Access Compliance Report Public Rights-of-Way (Curb Ramps)

Intersection ID: 10028782 Main Street: HUNTINGTOWNE FARMS LN Cross Street: N/A Location: SW

Overall Compliance: No Severity Score: ADA ID: 6EC0409DDDD6 Ramp Type: BlendTrans1 Initial Pass/Fail: Fail 8.75

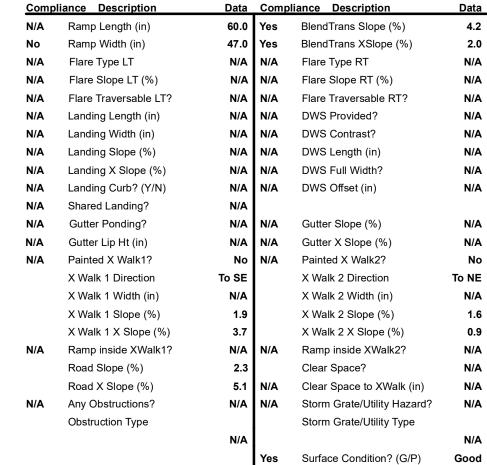
Street 1 Name Stop Condition-Street 1 Street 2 Name Stop Condition-Street 2 Remove & Replace Curb Ramp With Two New Directional Ramps or Equivalent.

Not Found, R304.5.1

Curb Slope (%)

3200.00
